2020-04-23

**REQUEST FOR PROPOSAL
CONSULTING SERVICES FOR
ROOF REPLACEMENT
RFP #27 (2020-04)
ADDENDUM #2**

- 1. DRAWINGS:** Higher quality PDFs of the drawings for the Canopy Classroom and Giraffe Building have been attached to this addendum. Square footage for the Canopy Classroom is included on the drawing, and some dimensions have been clarified on Giraffe drawing A-4.

CANOPY CLASSROOM A-4

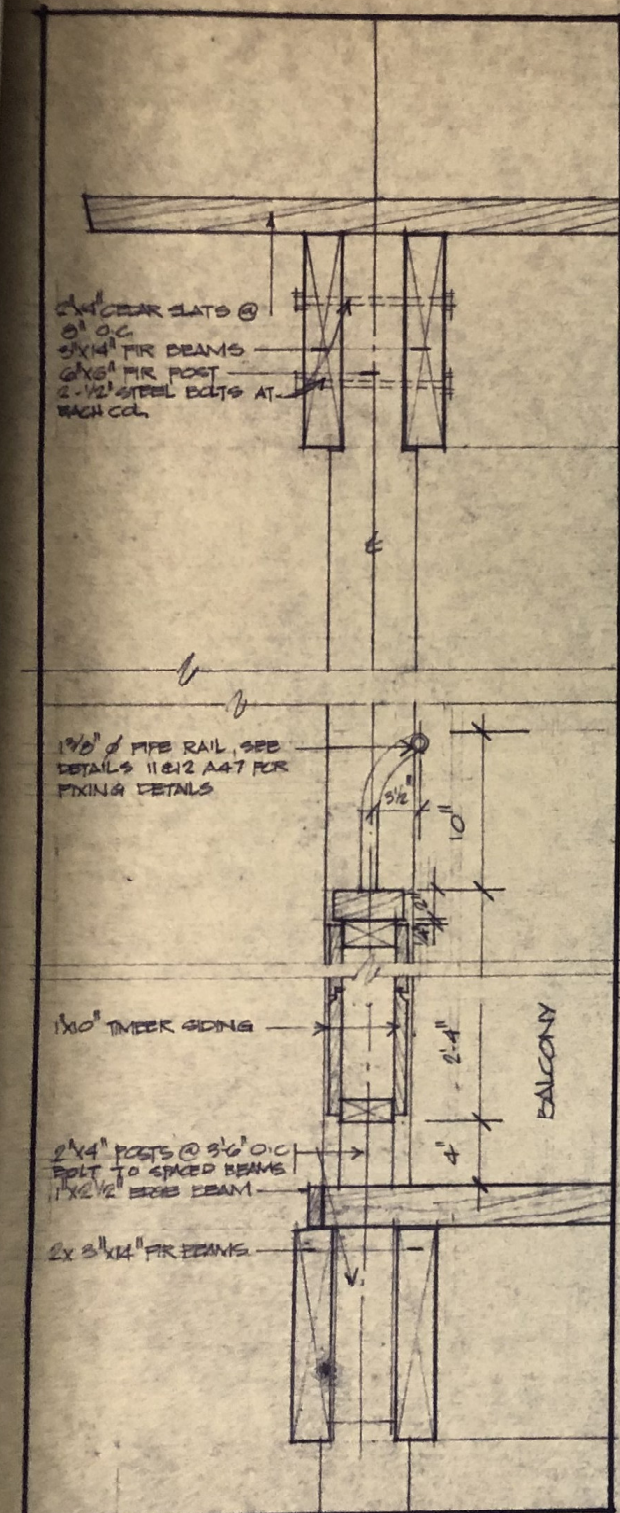
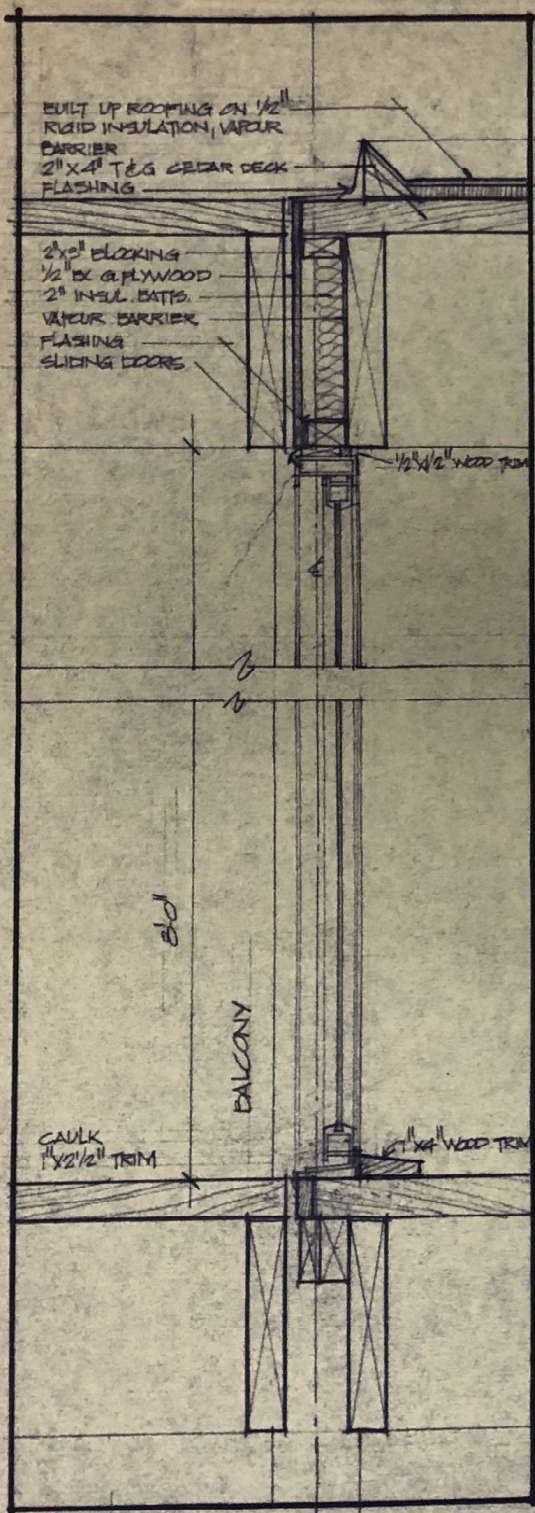
I have struggled with the provided drawing legibility to determine the sq. footages of the 3 properties for roof replacements and google maps is not much better as the trees are in the way. That being said, could you possibly give us the square footages for each of the 3 roofs that need repairs/replacements?

Please see attached higher quality PDFs. We have included the roof area for the Canopy Classroom and clarified some dimensions for the Giraffe building.

APPROX
1204 FT2
